**Re: Case No. 21-4-EL-BGN**

In the Matter of the Application of Tymochtee Solar, LLC for a Certificate of Environmental Compatibility and Public Need to Construct a Solar-Powered Electric Generation Facility in Wyandot County, Ohio

**Third Supplement to Application – Facility Layout – Updated Figure 3-2**

**Reference:** Inverter Adjustment and Panel Removal

Figure 03-2. Facility Overview

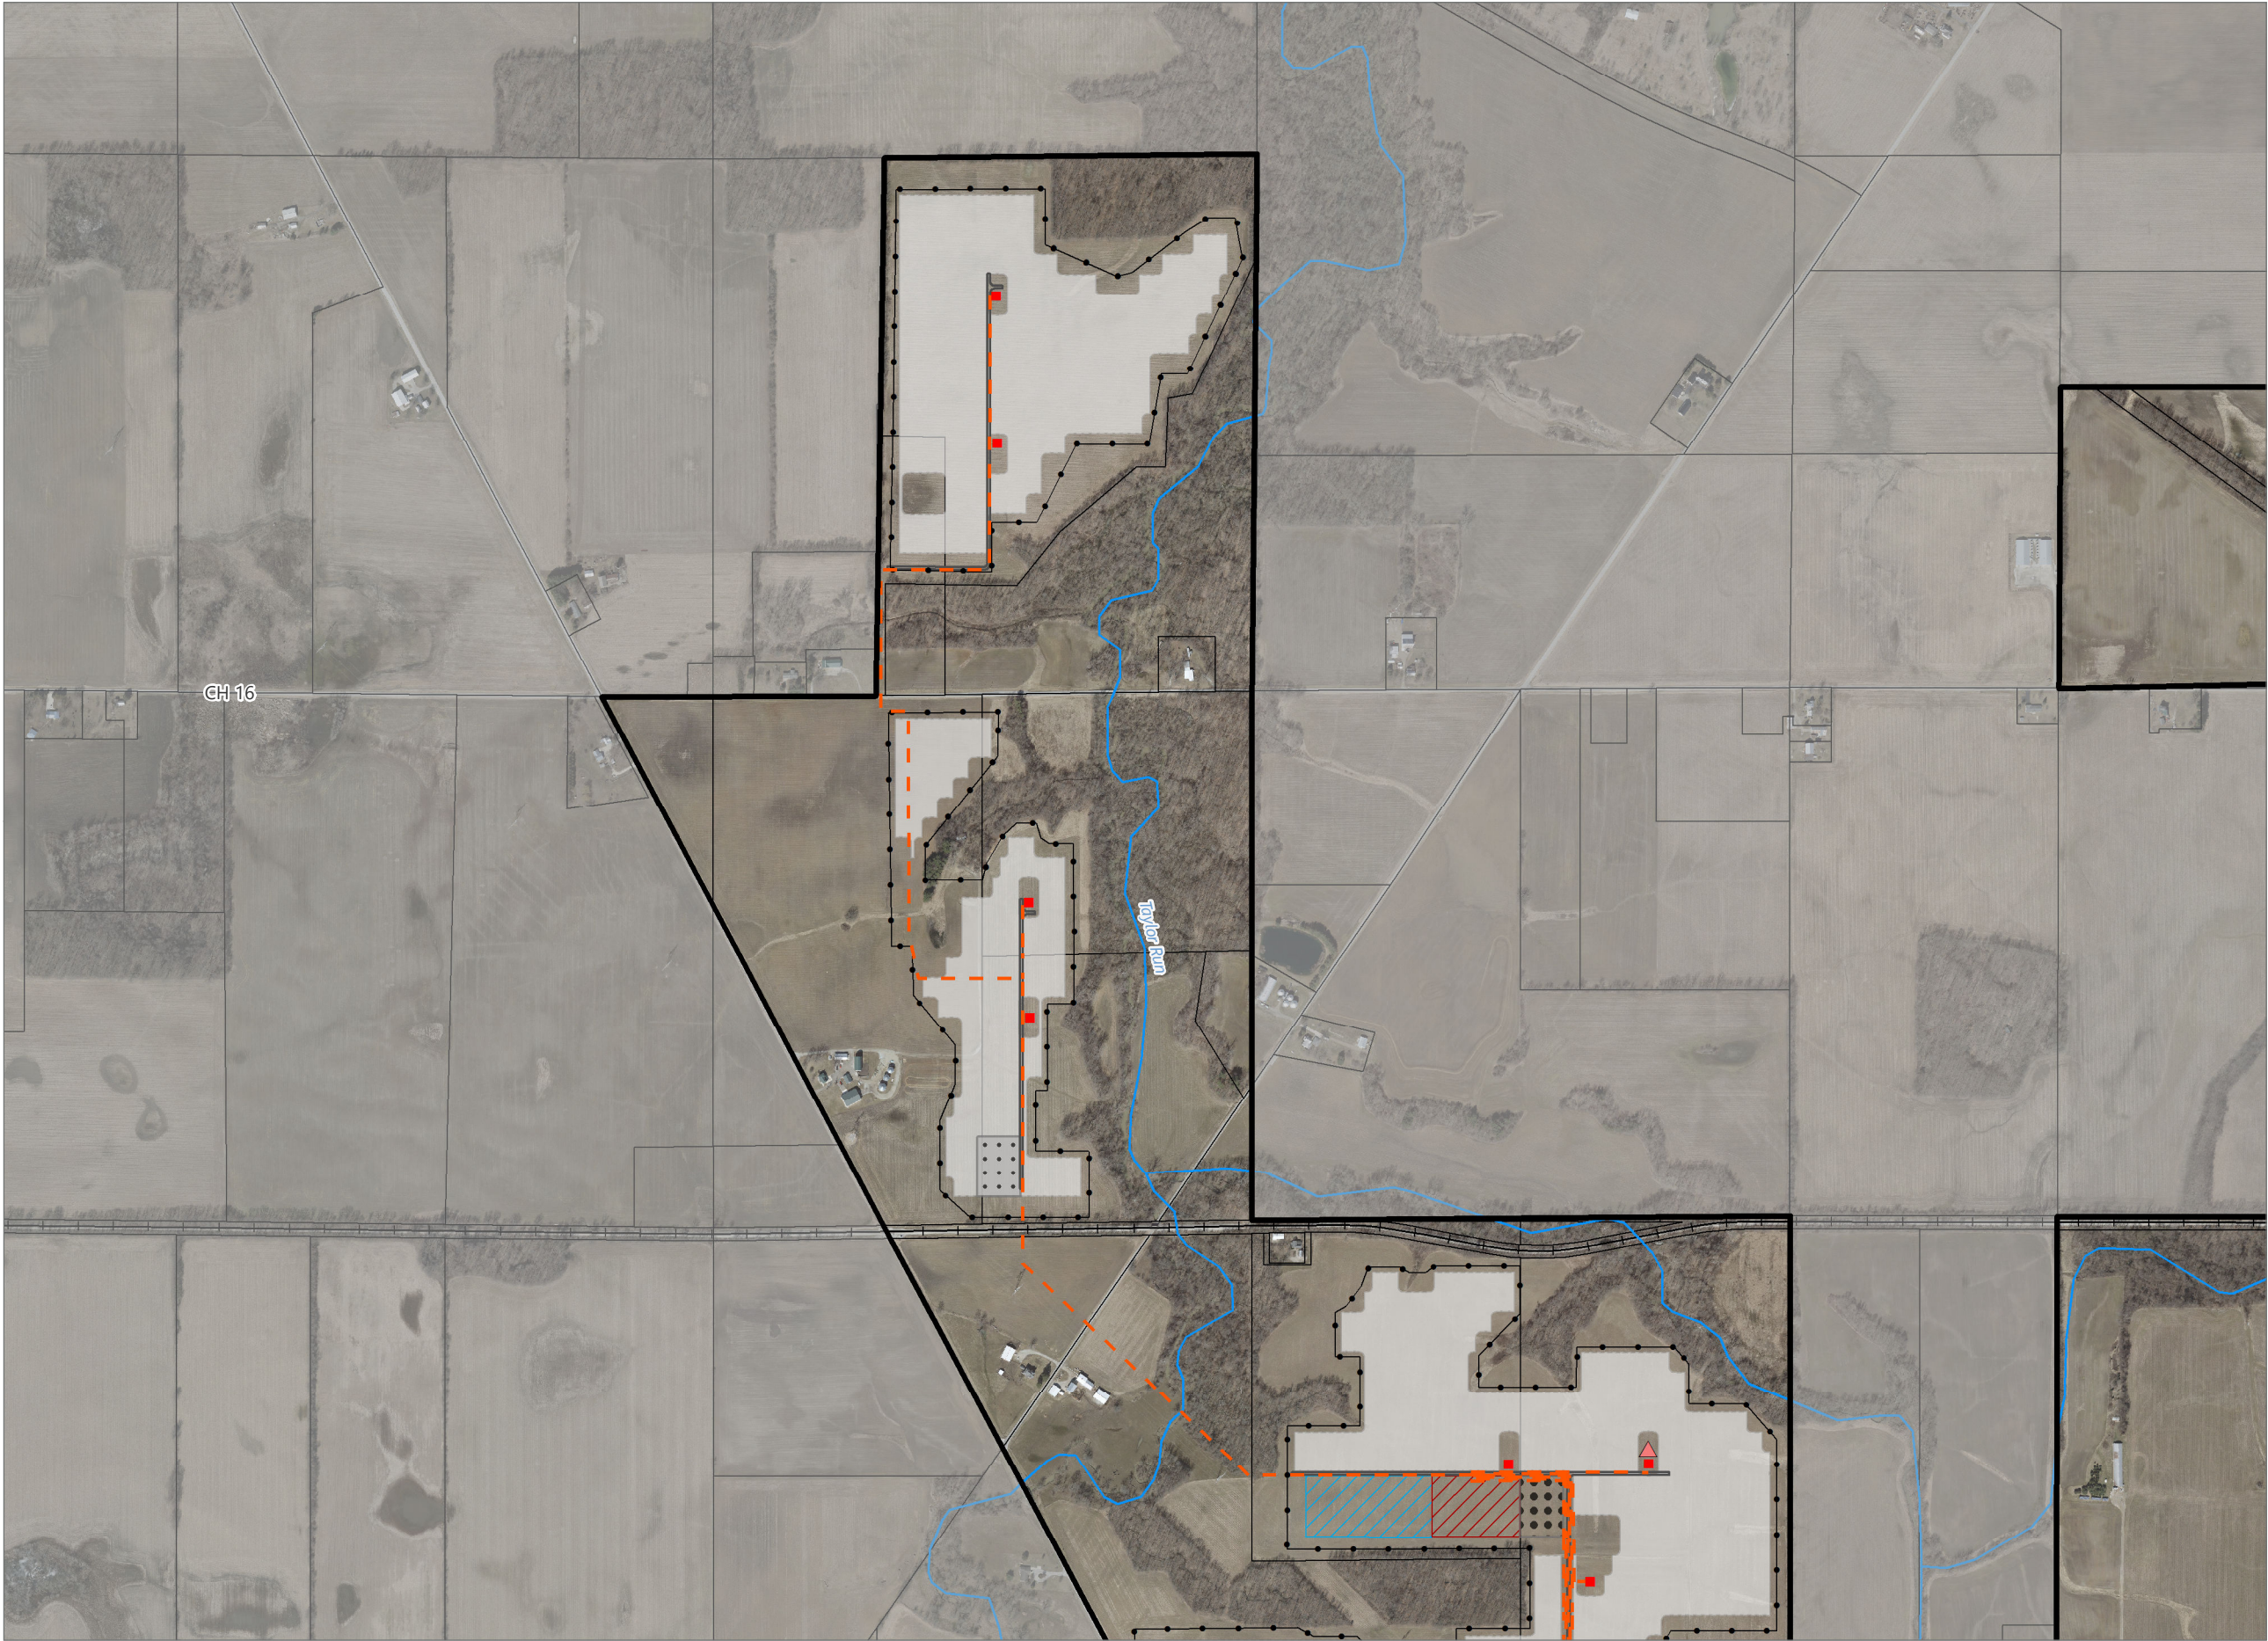
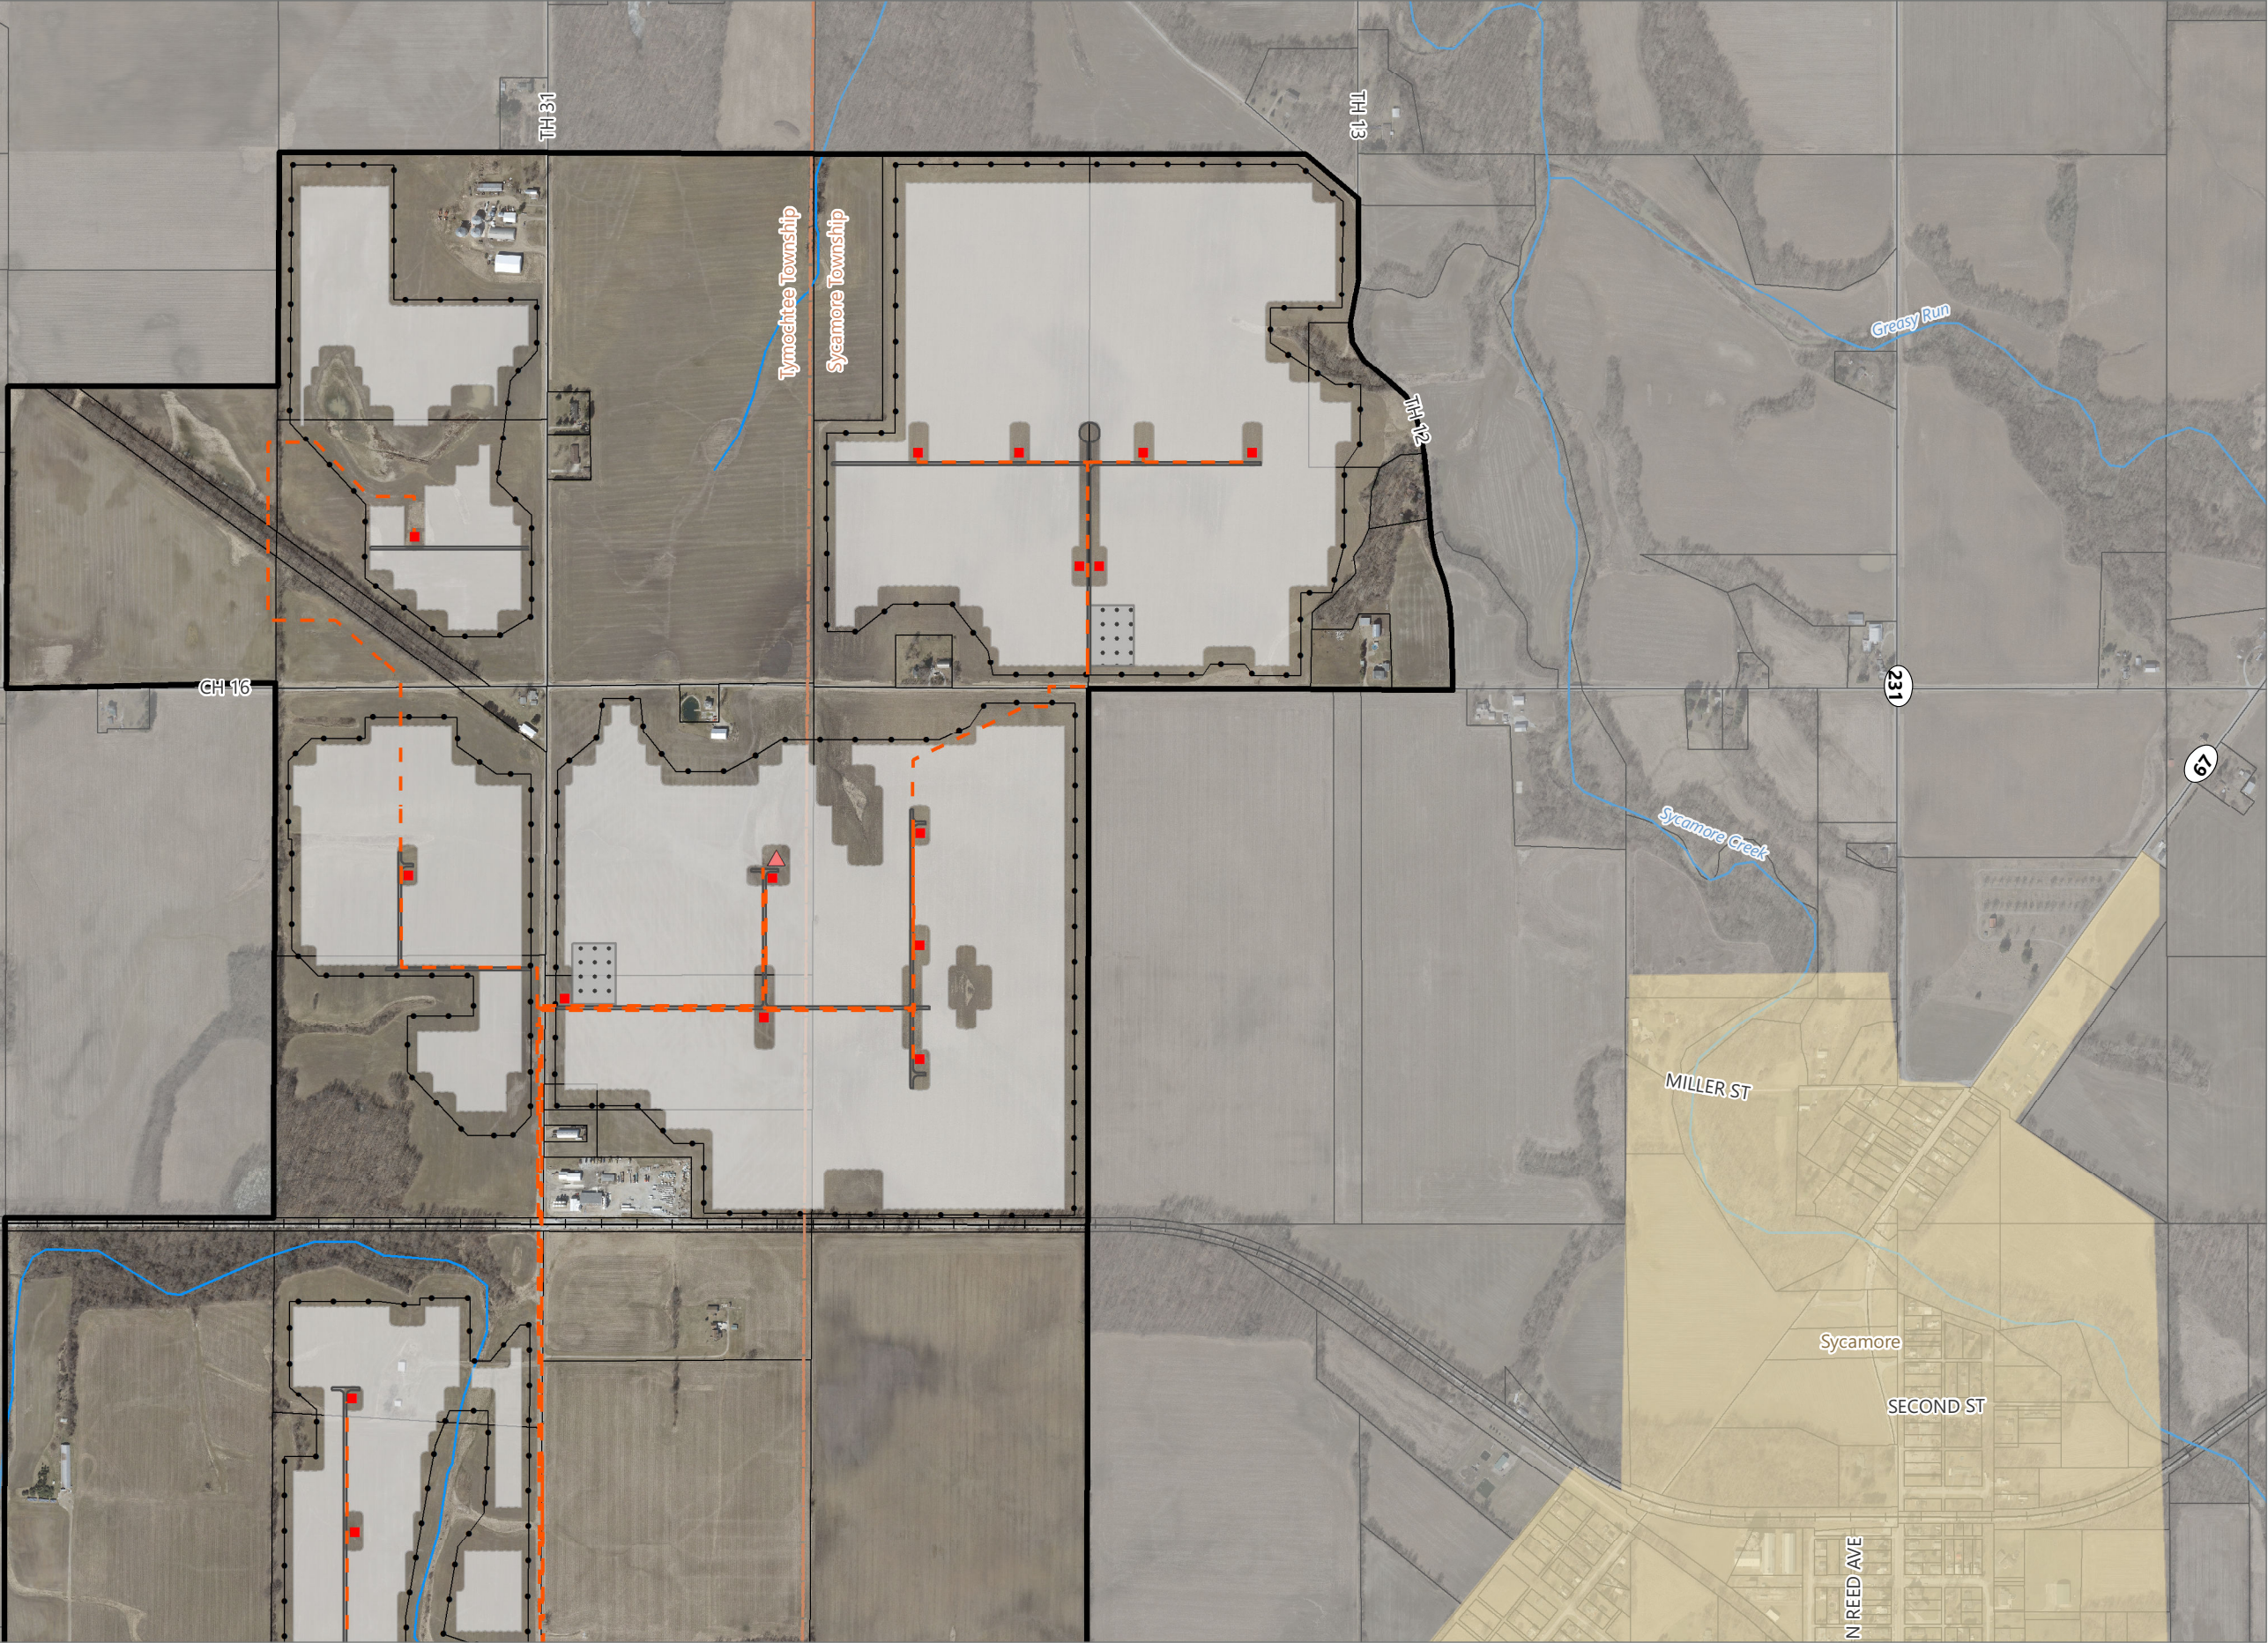
Additionally, to address feedback from Ohio's State Historic Preservation Office, panel arrays were removed at two locations, which are shown on sheets 2 and 3 of the attached Figure 3-2 Facility Overview with Highlighted Adjustments map. These adjustments are also included on the attached Facility Overview clean version of the updated Figure 03-2 map.
